BOURNS®
Product Update Memo
TRIMMERS

October, 2006

3214G/J and 3224G/J Product Improvement

Figure 1: J Pin Style

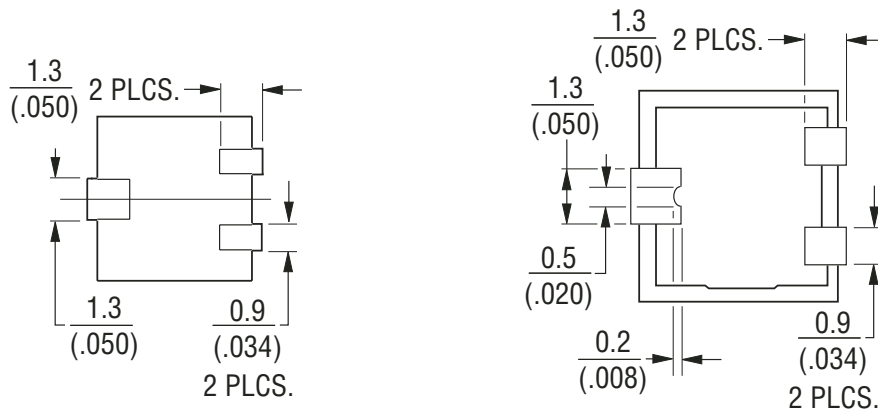
Bourns® Trimpot® Division is updating the lead-frame configuration on Models [3214](#) and [3224](#). This change will only affect pin styles G and J. This modification is a design improvement to allow increased manufacturing automation. The changes are illustrated in figures 1 and 2. Shipments with this modification will commence on October 16, 2006 (Date Code: 0642). There will be a transition period where both types of lead-frames will be shipped.
